**From:** [REDACTED]  
**Sent:** 19 February 2024 15:54  
**To:** [REDACTED]  
**Subject:** FW: Roman Roads Research Association report regarding DOV/23/01363 Goshall Valley, East Street, Ash  
**Attachments:** SR011-richborough-little\_south\_solar\_farm-Haken\_2024.pdf

## ASSESSMENT OF THE PROBABLE ROMAN ROAD NETWORK IN THE VICINITY OF THE PROPOSED LITTLE SOUTH SOLAR FARM, ASH

SITE REPORT NO. SR011

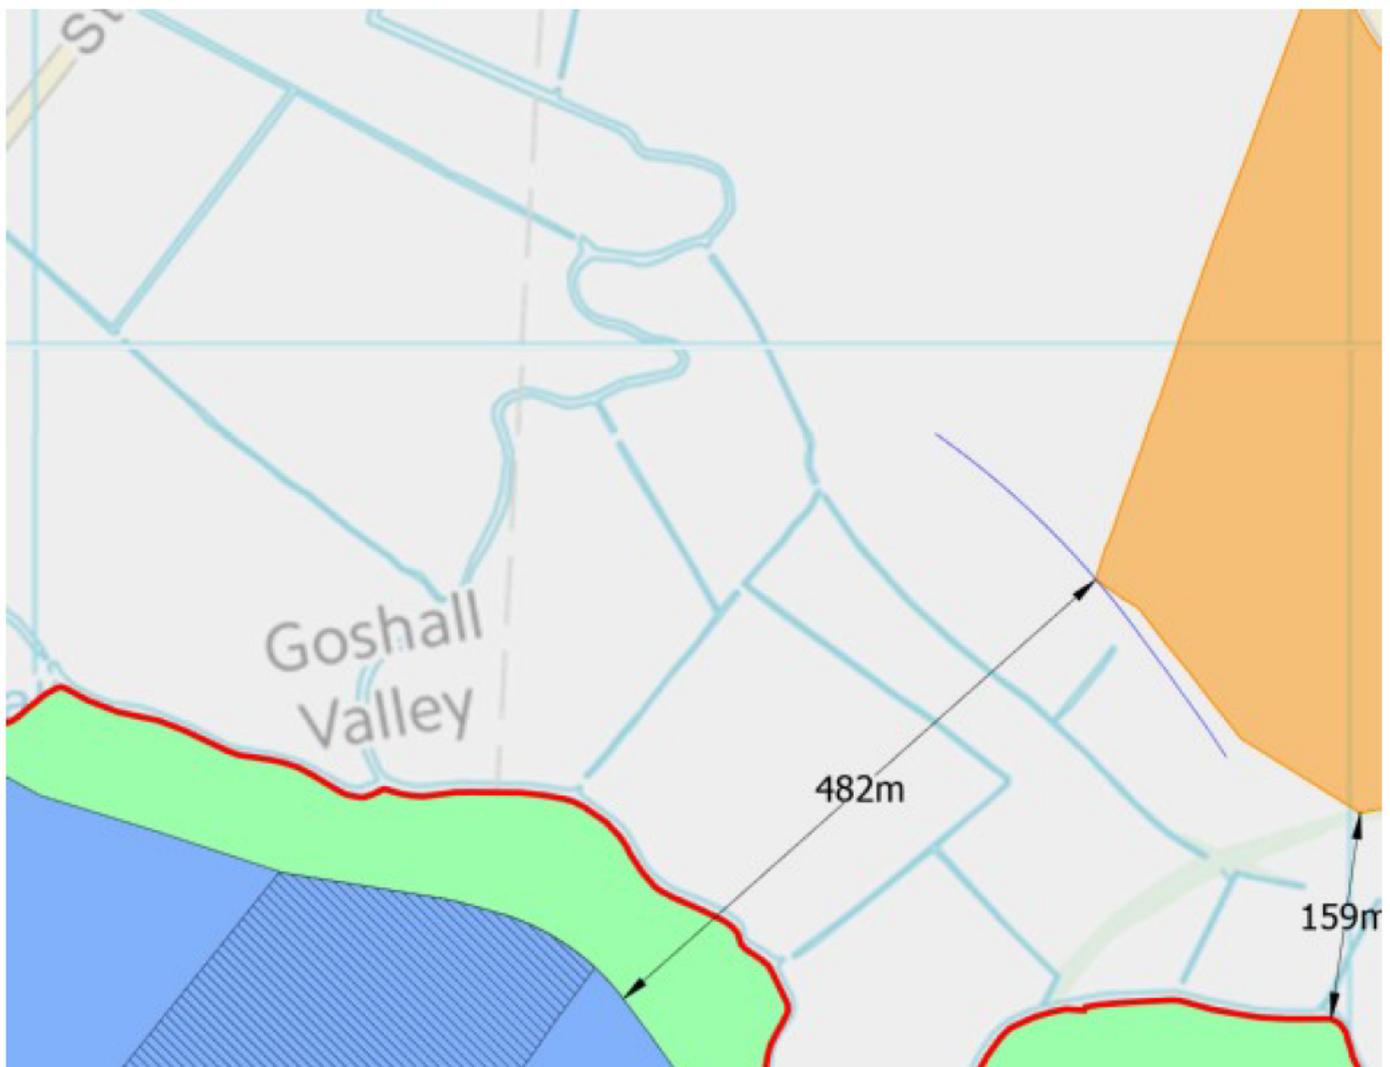
The image below demonstrates that there is a distance of 482m from the southwestern corner of the area designated SAM to the nearest point of developable area within the solar farm (blue shading). The green shaded area is proposed for a nature restoration area and planting and will not be used for solar panels.

I have checked the quoted distances using our GIS system and as per my consultation response to the Local Planning Authority I can confirm that at its closest point the development site (that is the redline planning application boundary) is located some 160m from the scheduled monument.

Richborough Castle and the amphitheatre form component parts of a much larger Roman site covered by a single scheduling (1363256). The scheduled monument extends south of the amphitheatre site (towards the proposed development site). The scheduled monument covers a large part, but not all, of the Roman site at Richborough. Thinking of Roman Richborough only in terms of the amphitheatre and standing walls of the Shore Fort is wrong. The whole of the scheduled monument is of national importance and there is a strong probability that important archaeological remains will extend outside the boundaries of the scheduled area.
